BQ25890 Ship Mode

No VBUS

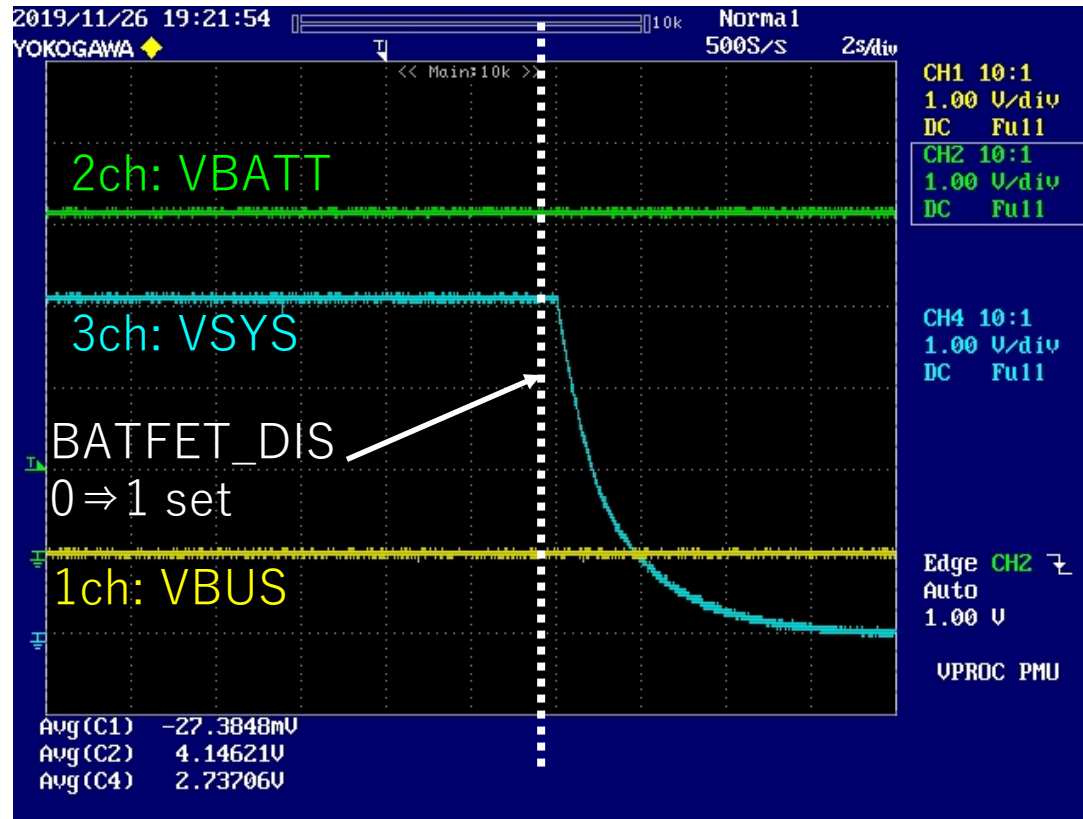
VSYS Stop is OK

VBUS ON

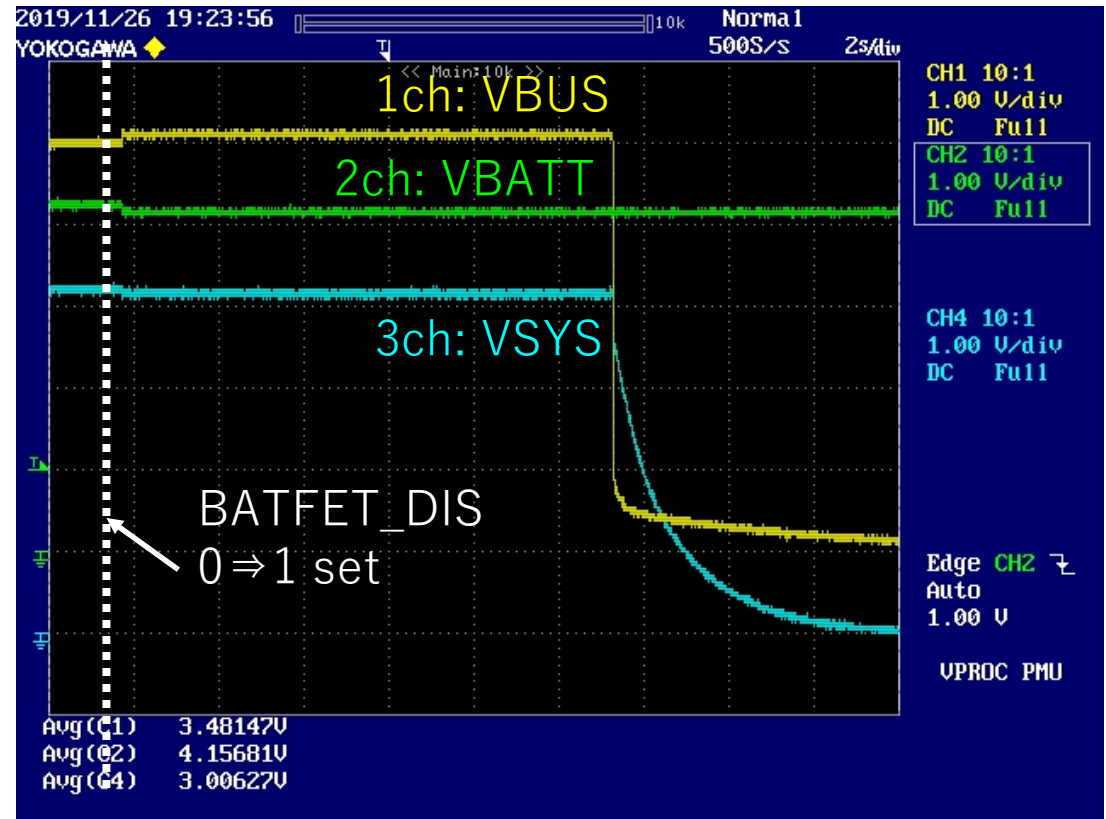
VSYS Non stop.
VSYS stop (ship mode) can after VBUS stop.
Is it correct?
